CROSS SECTIONS

REVISED NDC02	STATE VA.	ROUTE 621	STATE PROJECT 6234-076-266, C-501, RW-201	SHEET NO. X178
------------------	--------------	--------------	--	-------------------

Ramp 1A

REVISED NDC02	STATE	STATE	PROJECT 6234-076-266, C-501, RW-201	SHEET NO. X186
	VA.	621

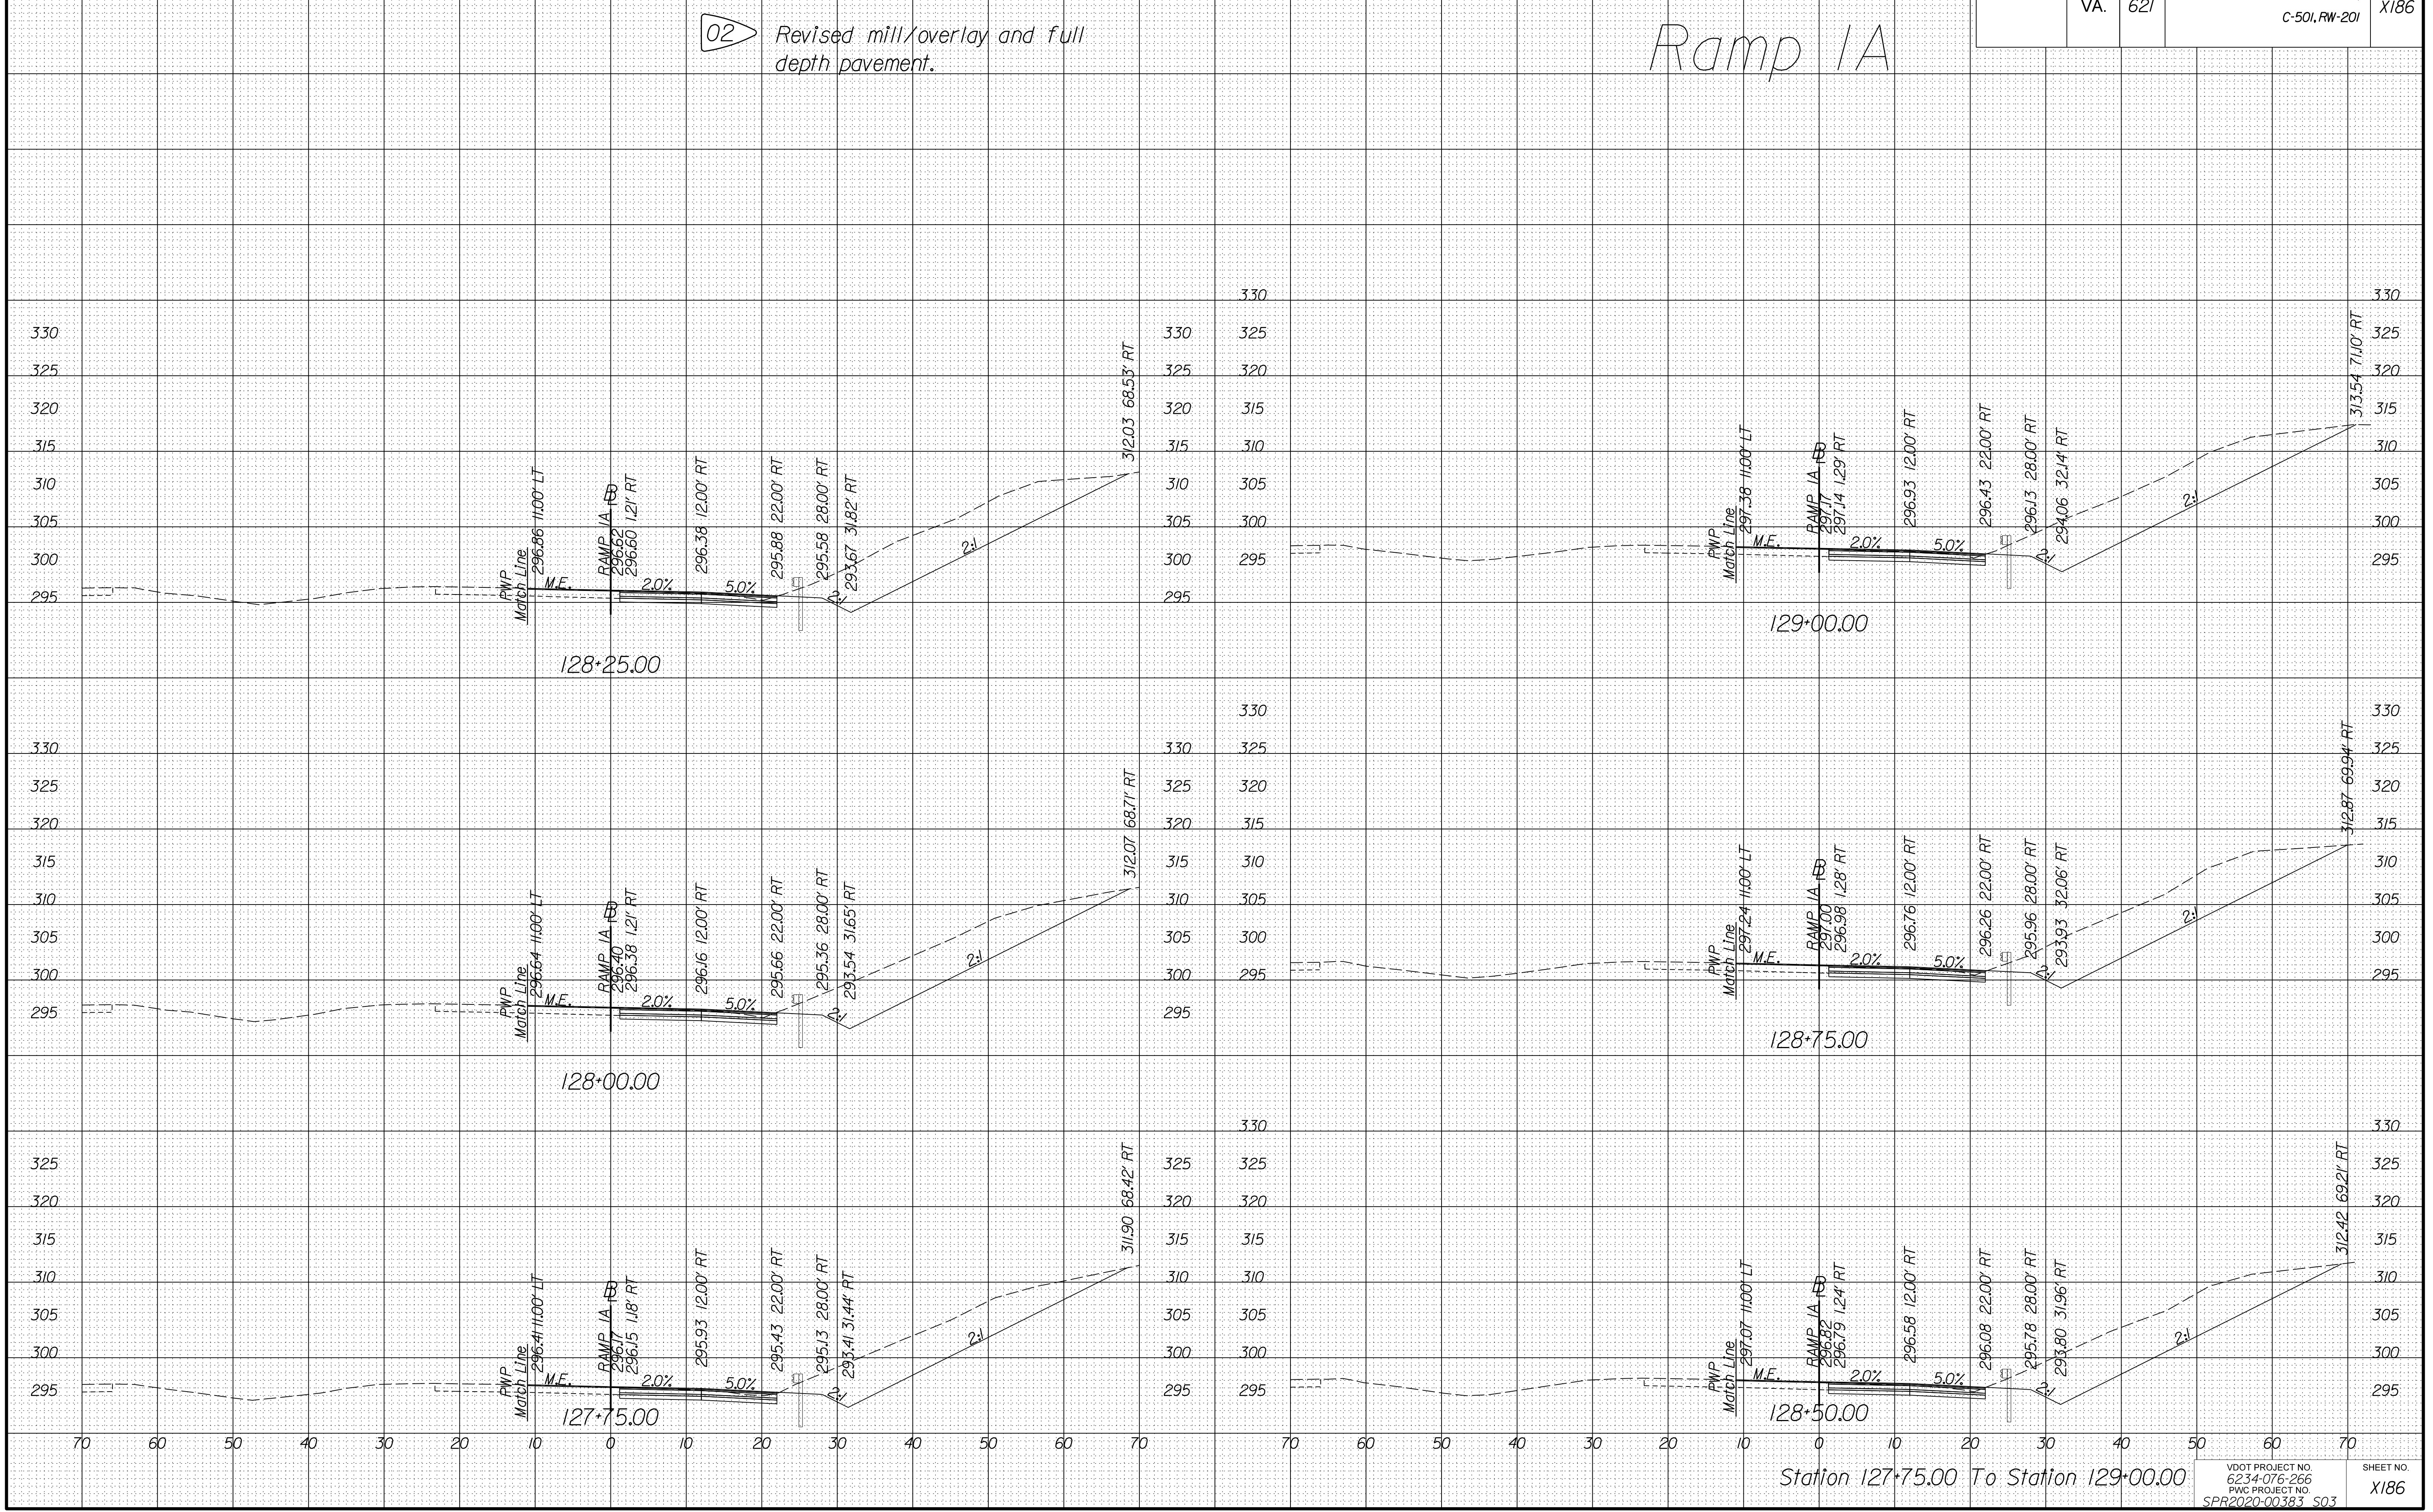
02 Revised mill/overlay and full depth pavement.

REVISED NDC02	STATE	STATE	PROJECT 6234-076-266, C-501, RW-201	SHEET NO. X187
	VA.	621

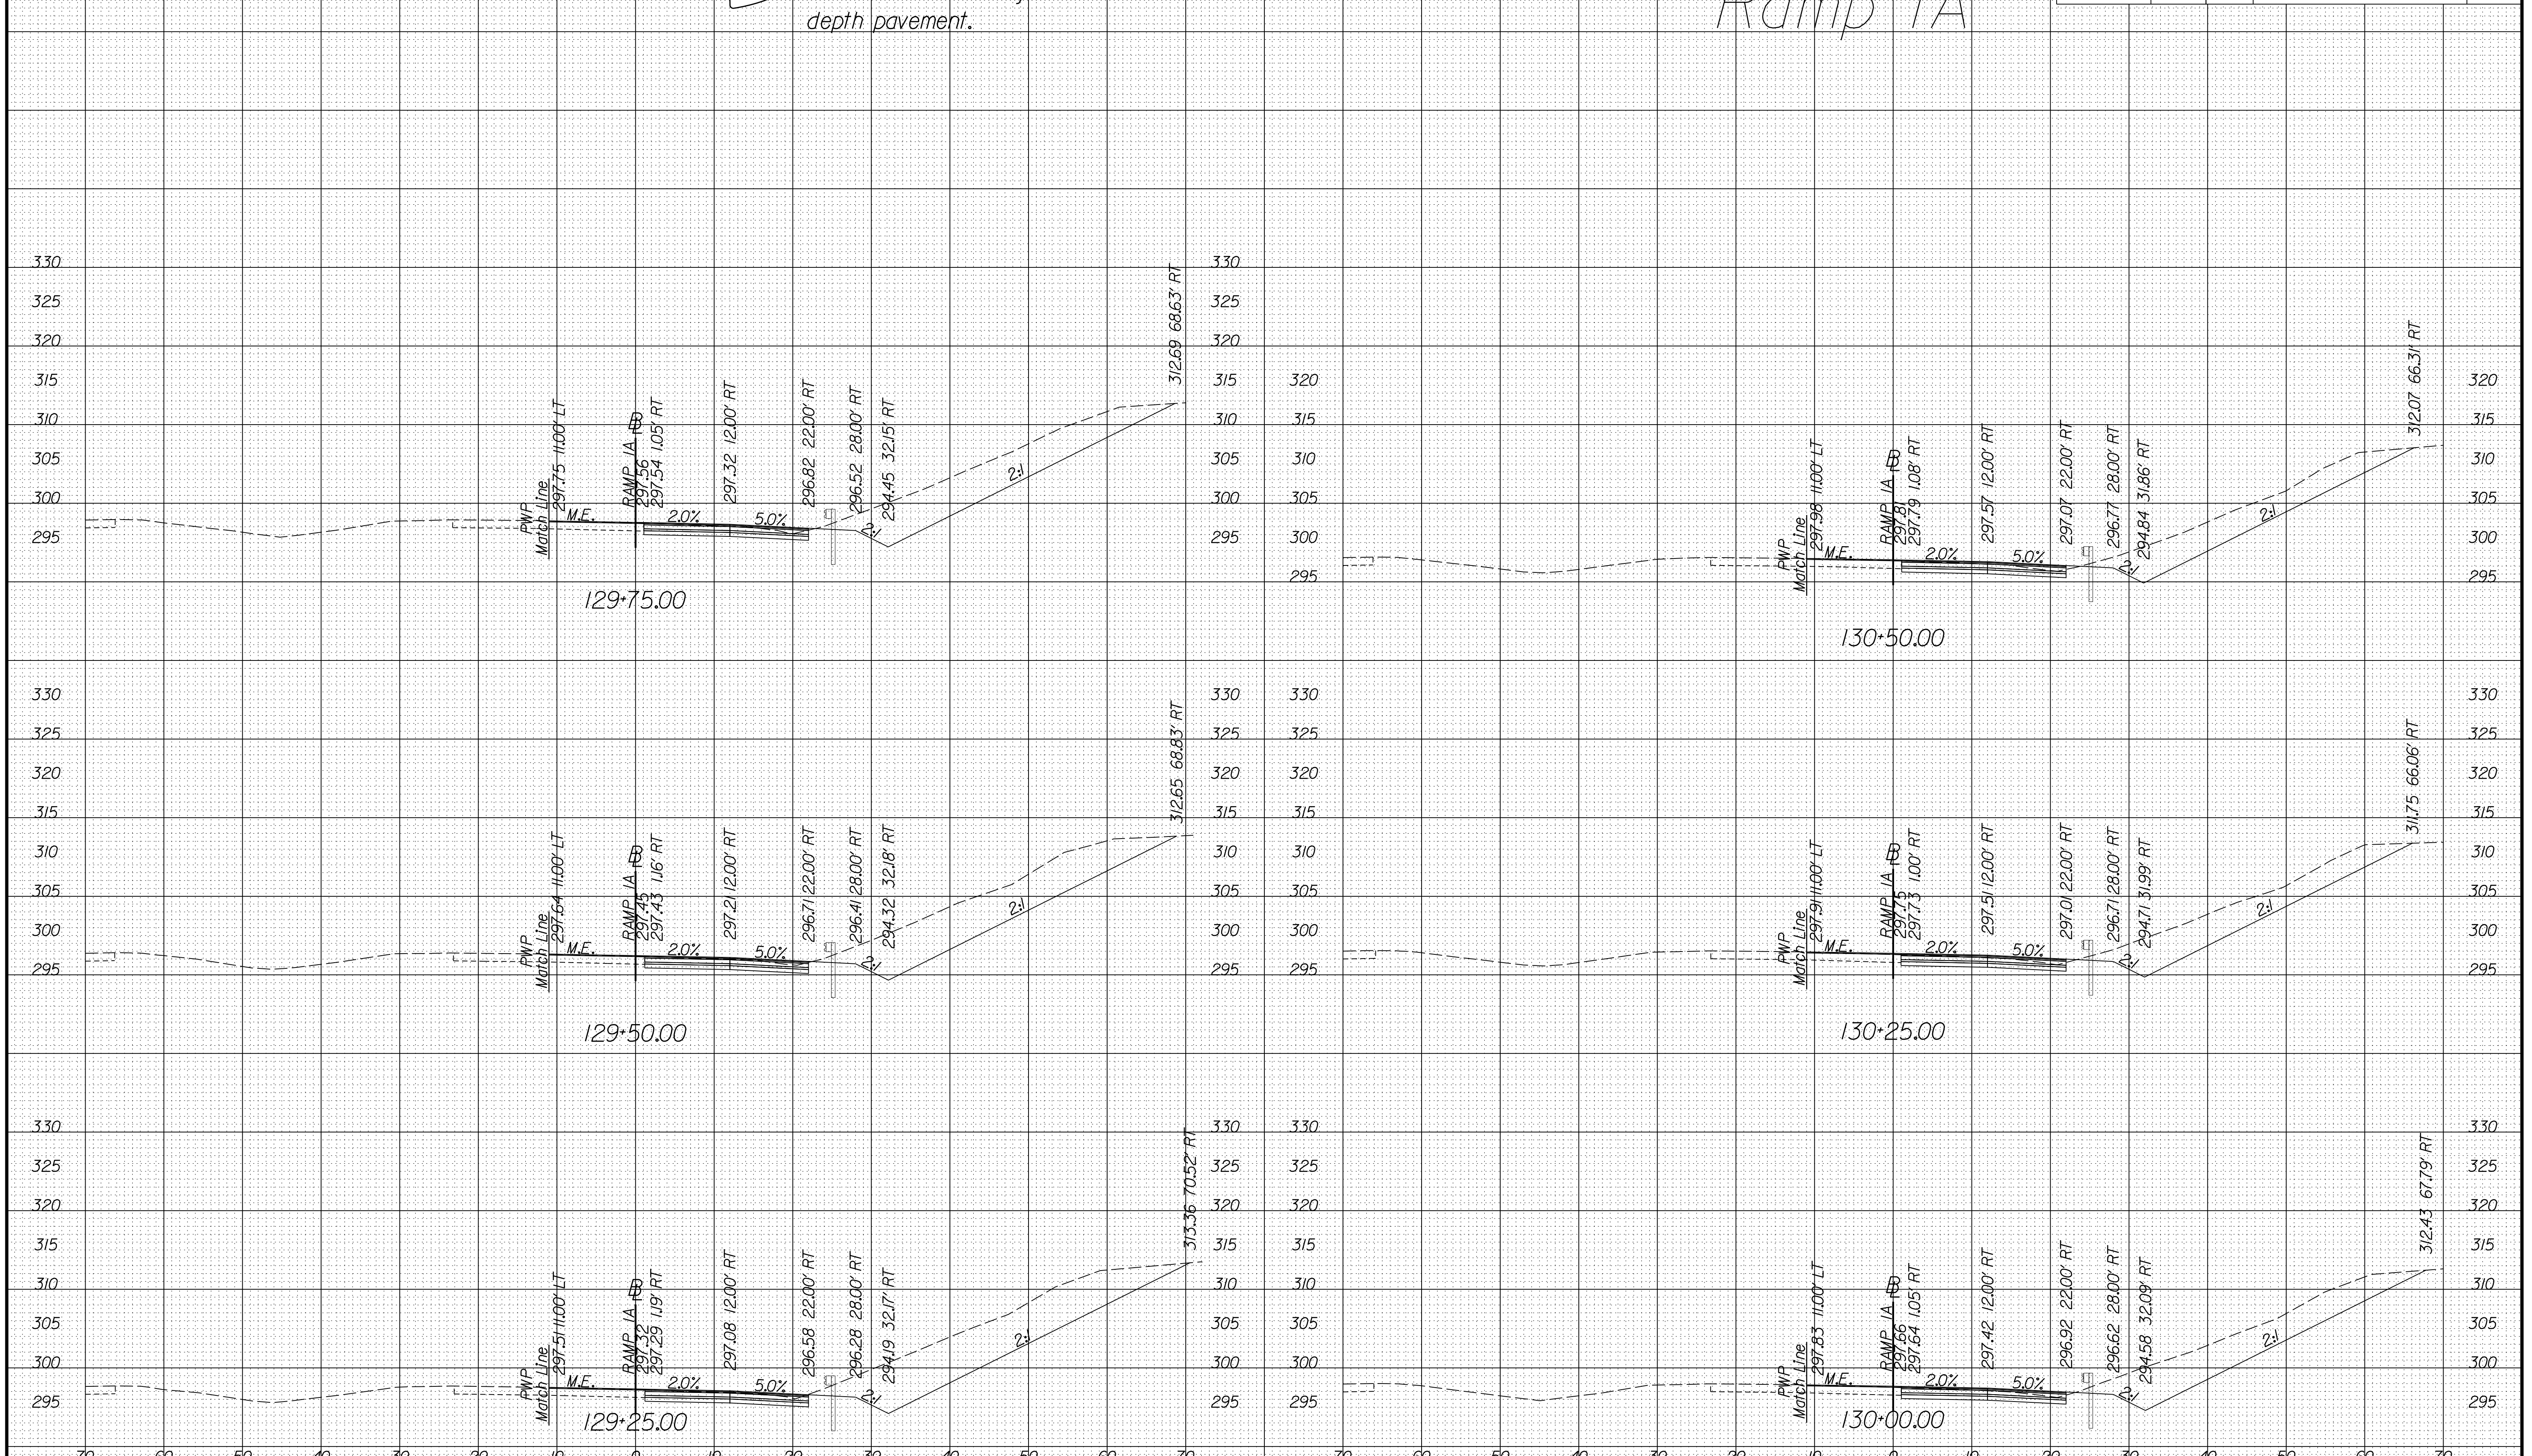
02 Revised mill/overlay and full depth pavement.

REVISED NDC02	STATE VA.	ROUTE 621	STATE PROJECT 6234-076-266, C-501, RW-201	SHEET NO. X230
------------------	--------------	--------------	--	-------------------

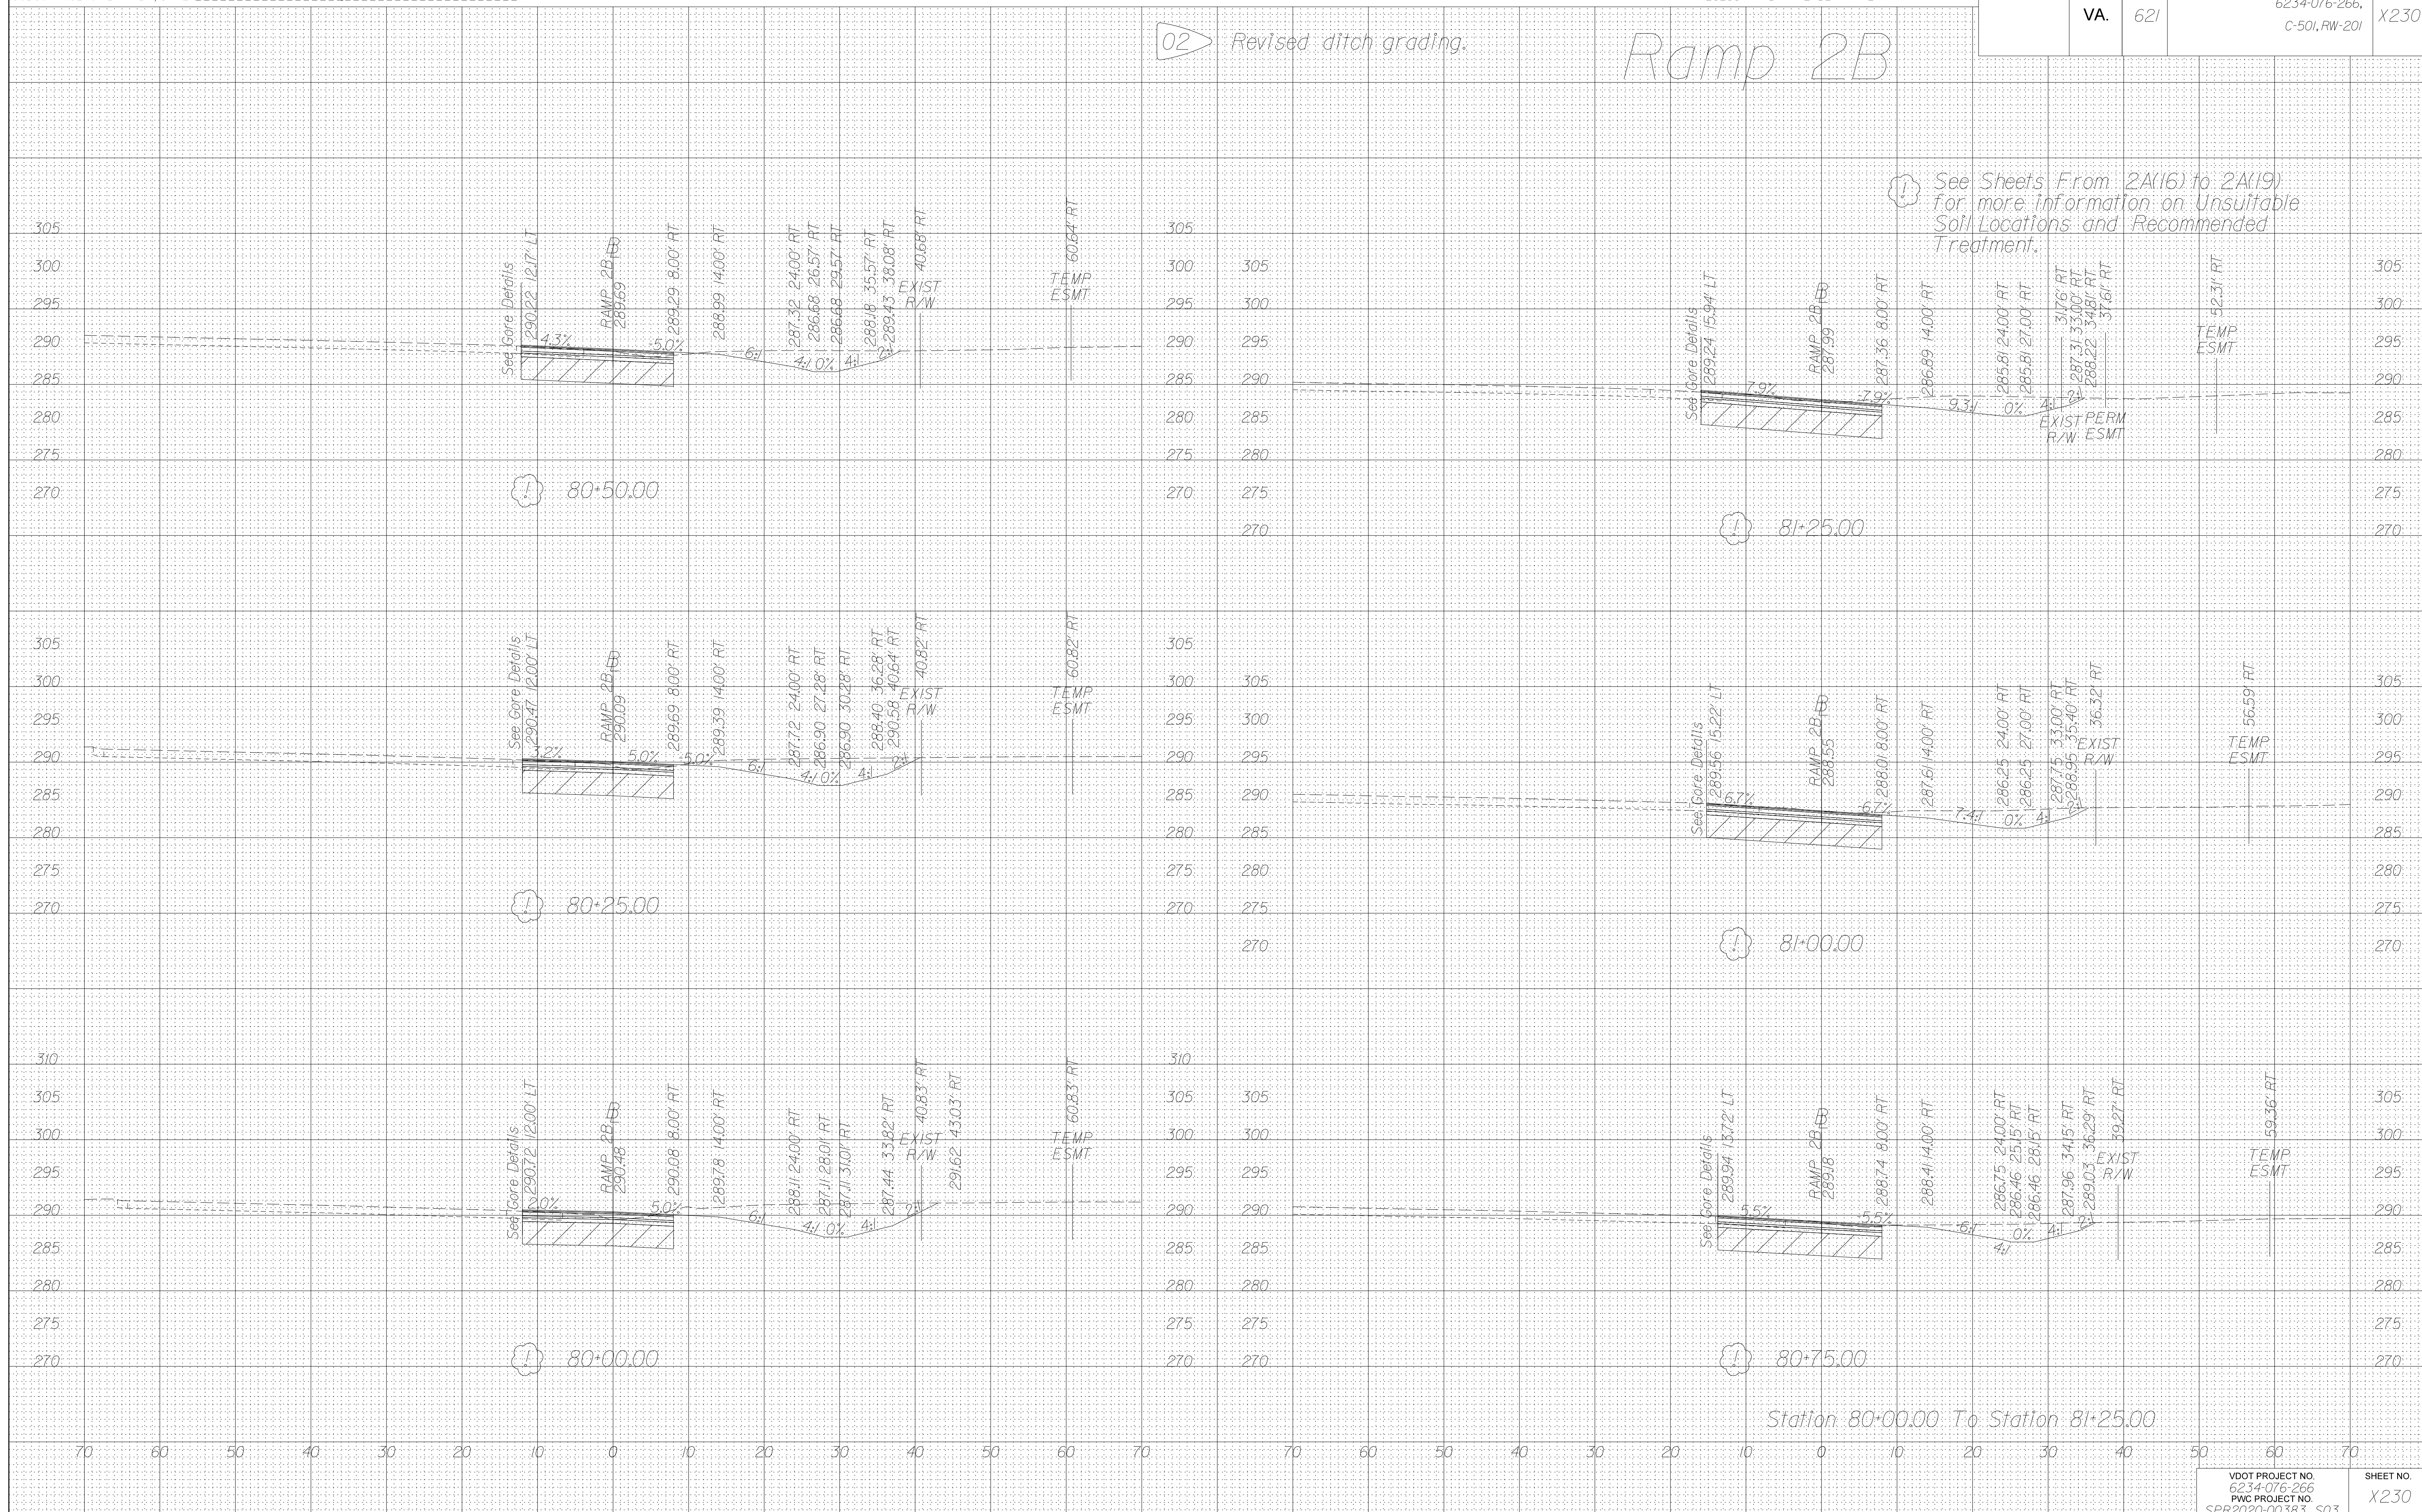
02 Revised ditch grading.
